Environmental Minor Project Refinement Form

Project Name: West of Devers Upgrade **Request Prepared By:** Sylvia Granados

Project Date Approval Required: 6/9/2020 **Variance Request No.:** 37

Southern California Edison
West of Devers Upgrade Project
Proposed Scour Protection Areas
MPR #37

6N23

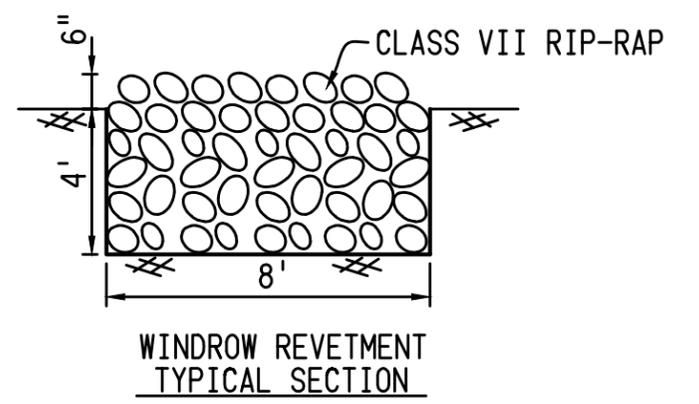
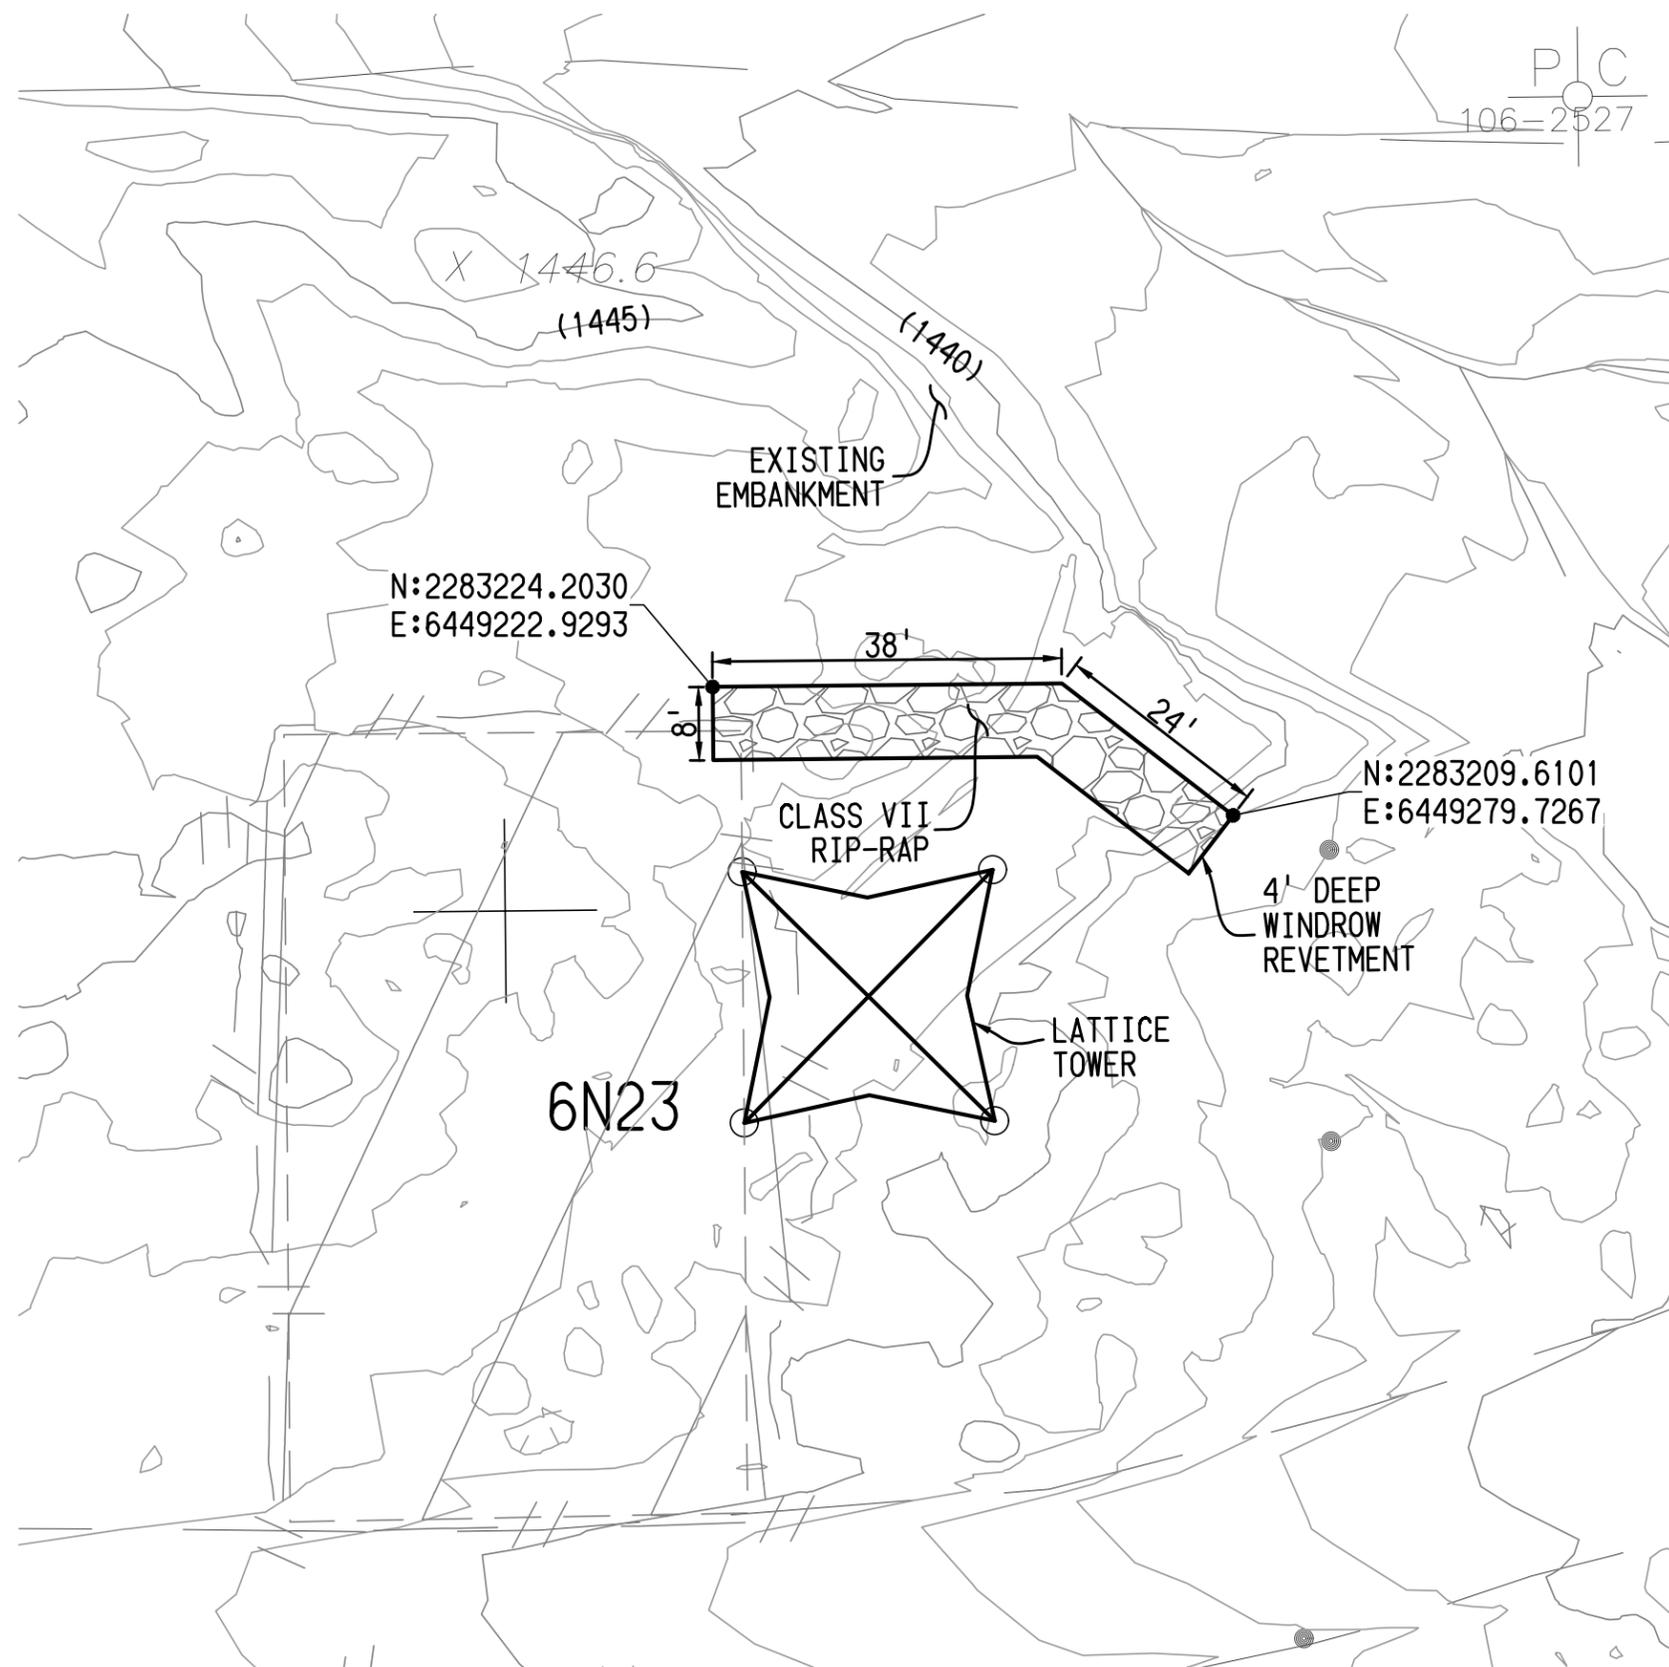
⁷ Expected high velocities near site require a high class of rip-rap to be utilized. Due to the size of rip-rap, a windrow revetment is the recommended countermeasure. See Appendix B site exhibit for details.

6S41

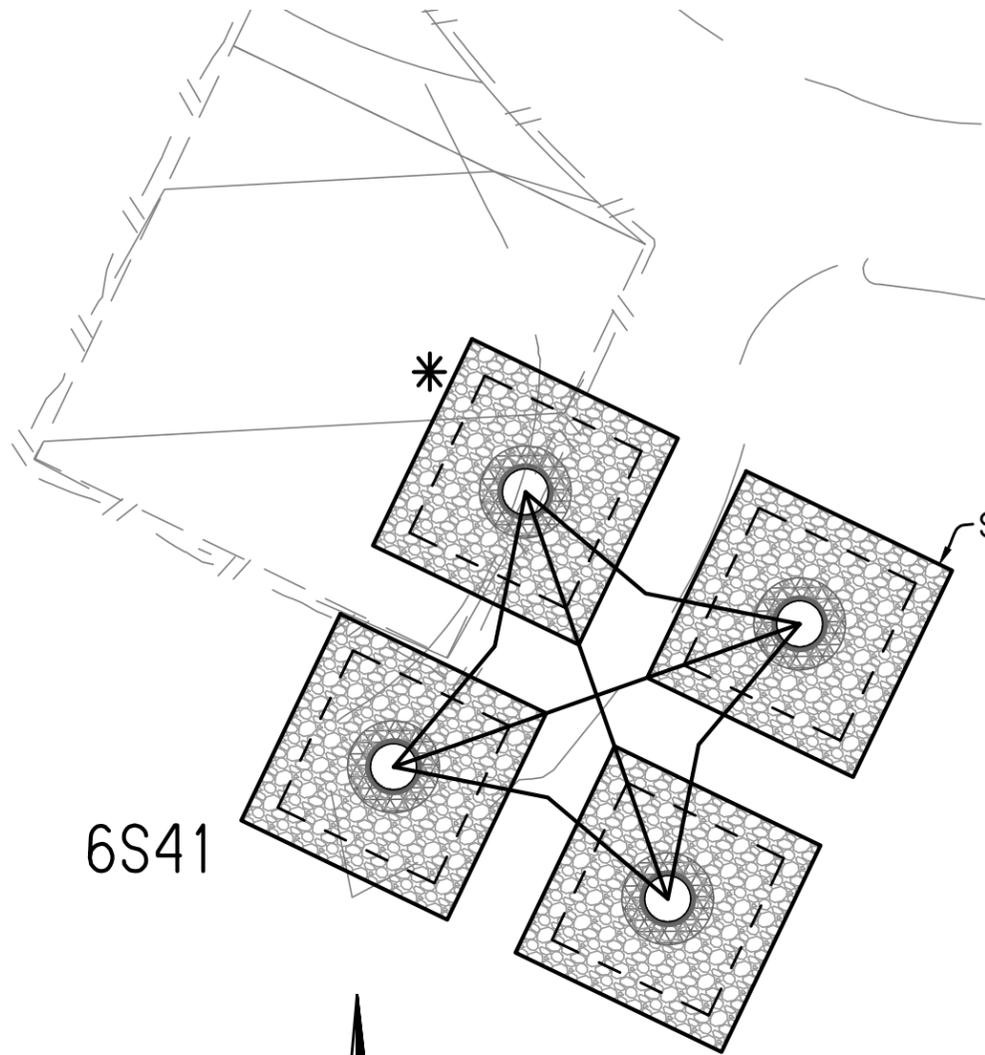
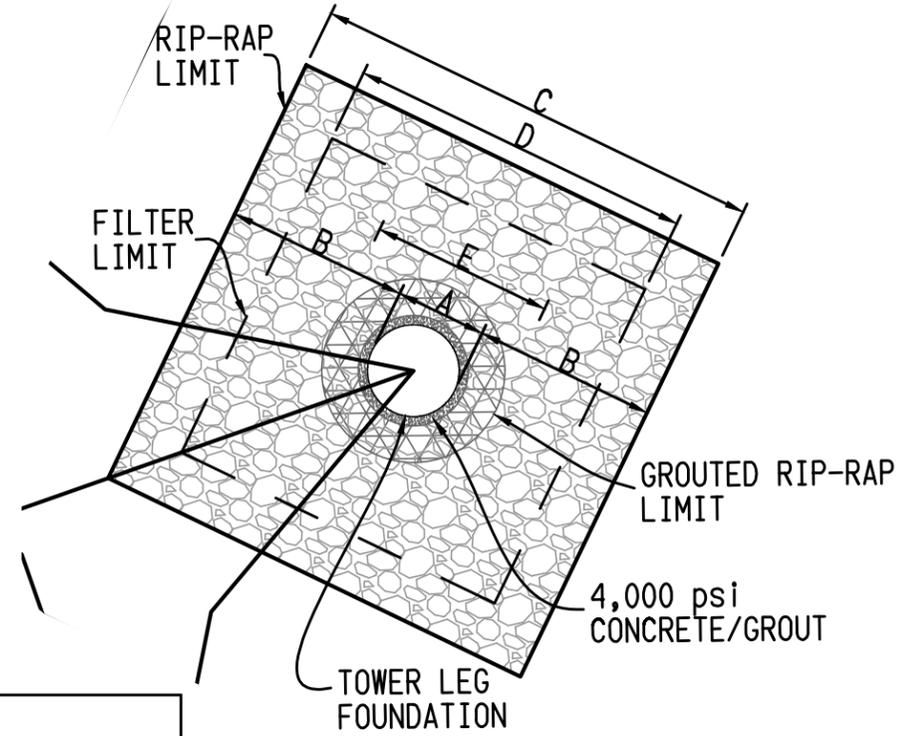
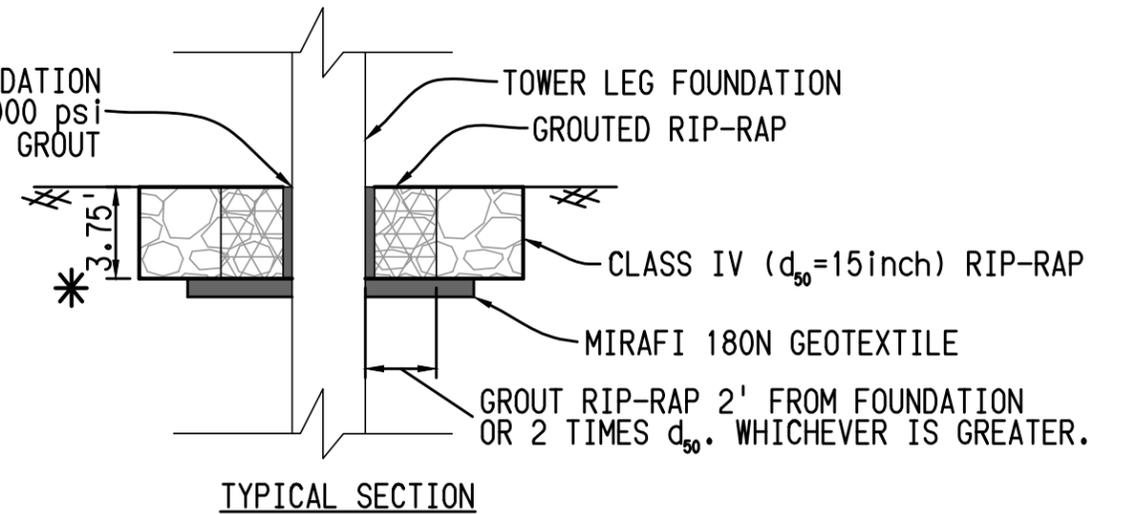
* FOR 6S41 NORTH-WEST TOWER LEG,
BURY RIP-RAP WITH 2-FOOT OF COVER TO MAINTAIN
ACCESS ACROSS PAD. DEPTH TO BOTTOM OF
RIP-RAP EQUAL TO 5.75'.

FILL GAPS BETWEEN FOUNDATION
AND RIP-RAP WITH 4,000 psi
CONCRETE OR GROUT

6N42 & 6S42

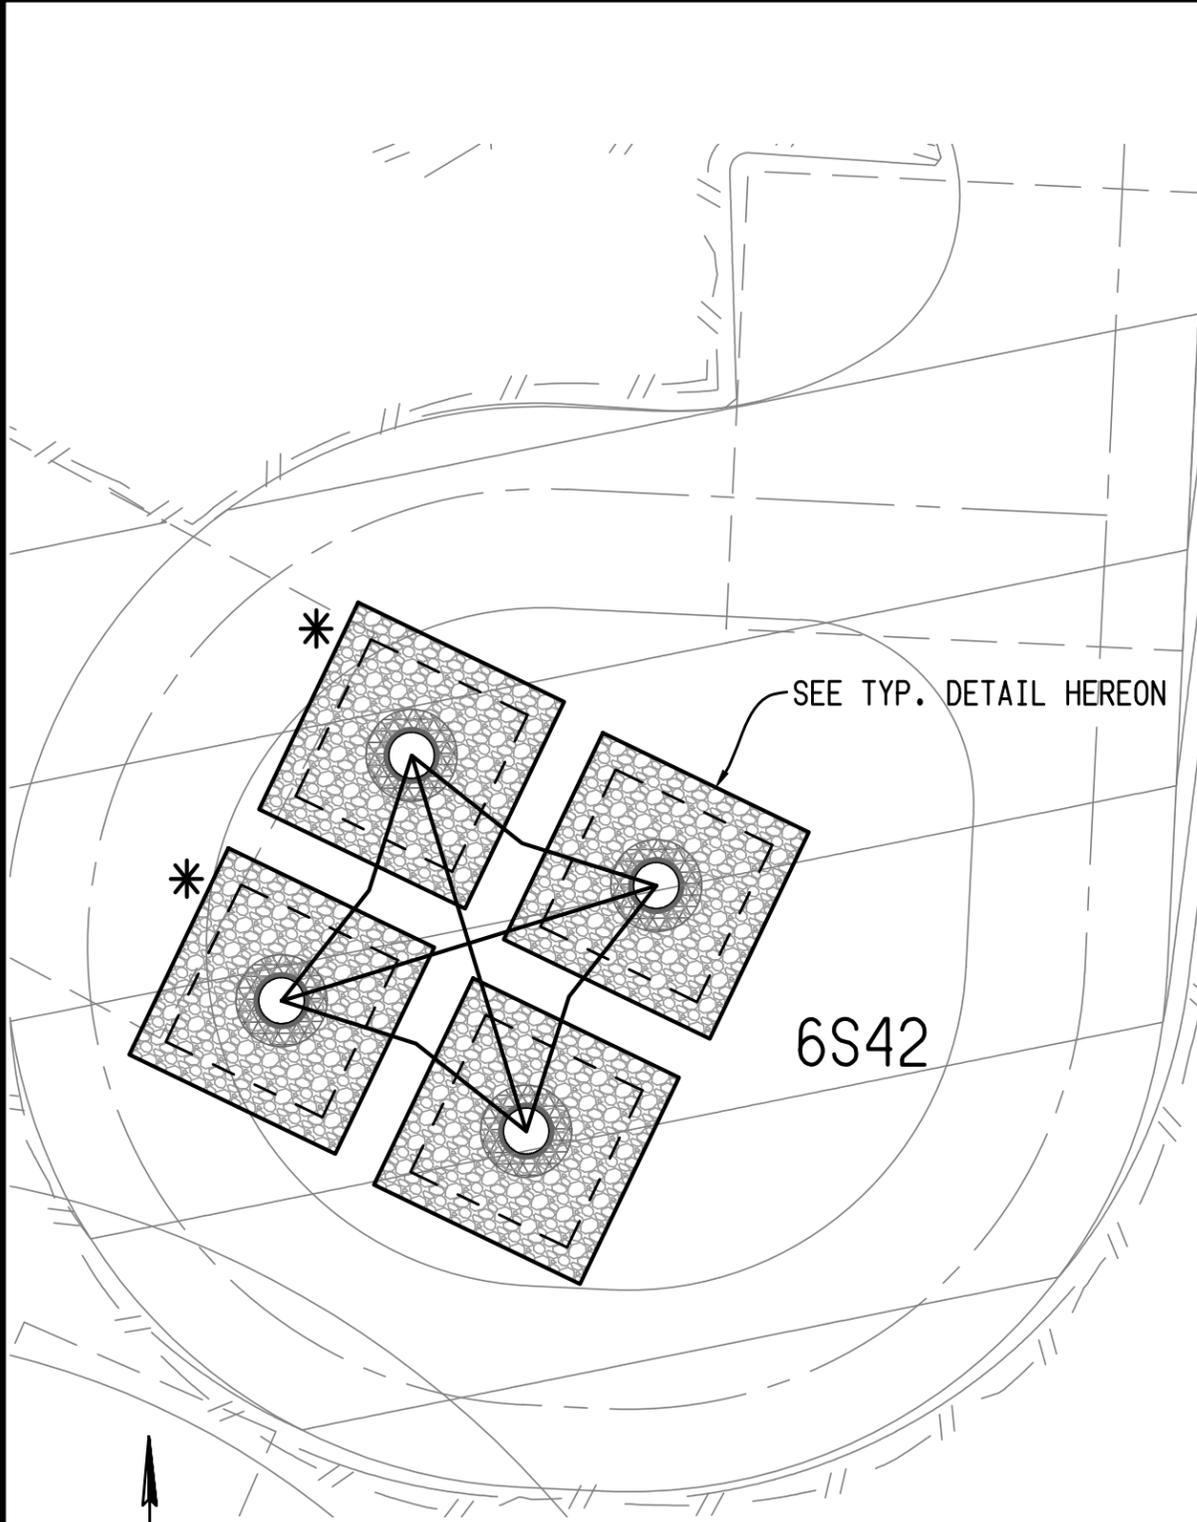
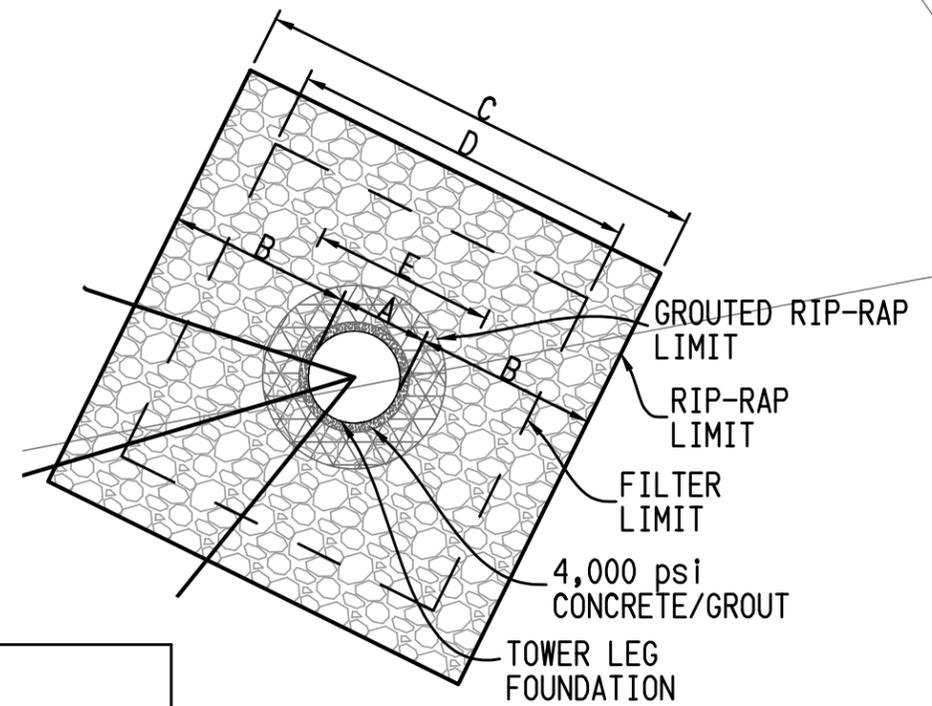
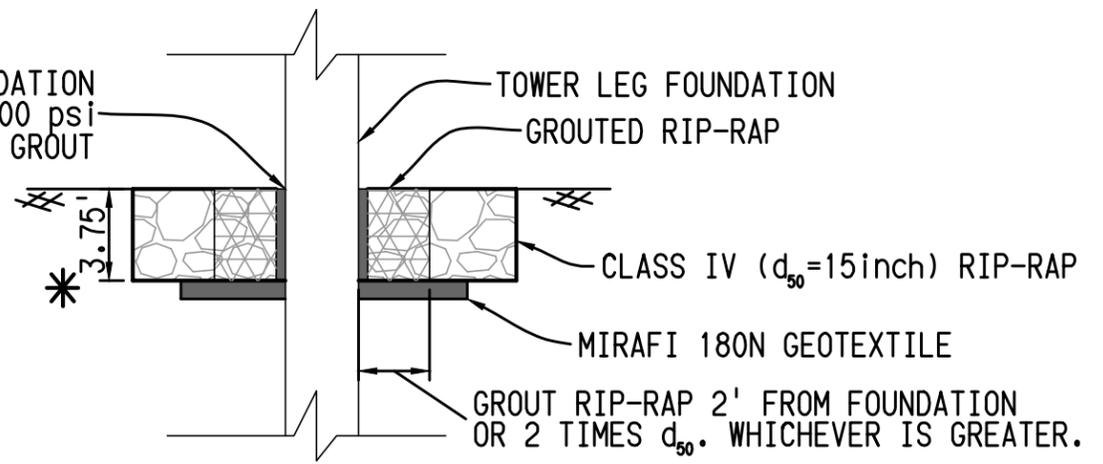
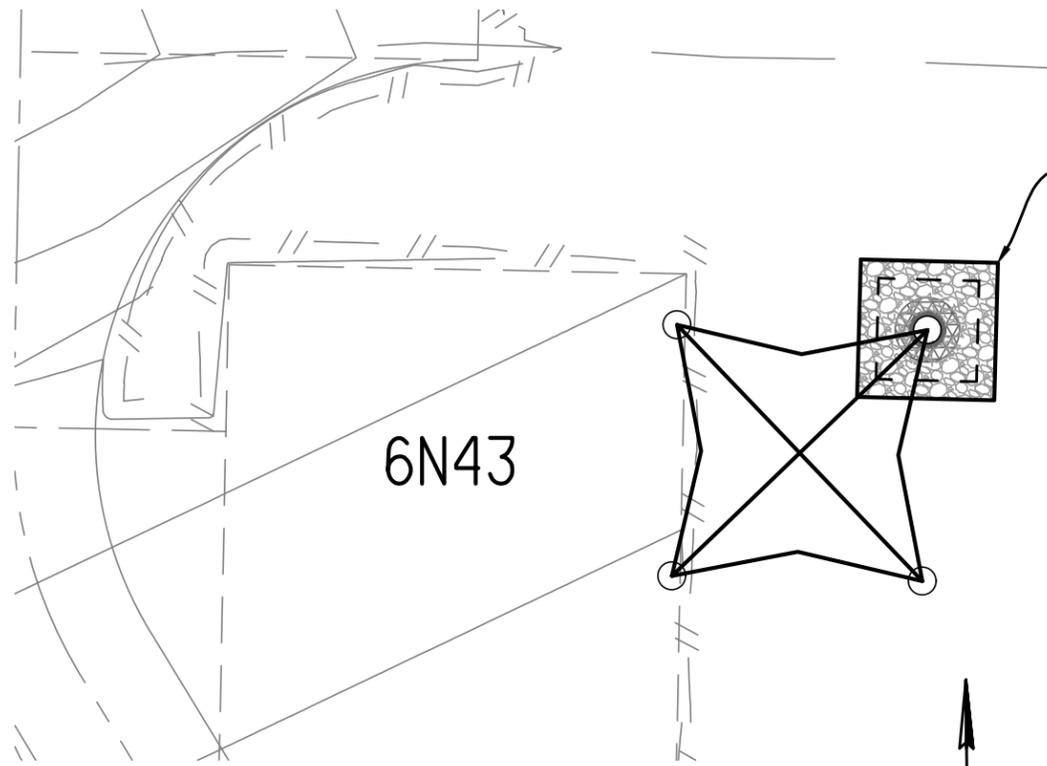
* FOR 6S42 NORTH-WEST AND SOUTH-WEST TOWER LEGS, BURY RIP-RAP WITH 2-FOOT OF COVER TO MAINTAIN MOVEMENT ALONG ACCESS ROAD. DEPTH TO BOTTOM OF RIP-RAP EQUAL TO 5.75'.

FILL GAPS BETWEEN FOUNDATION AND RIP-RAP WITH 4,000 psi CONCRETE OR GROUT
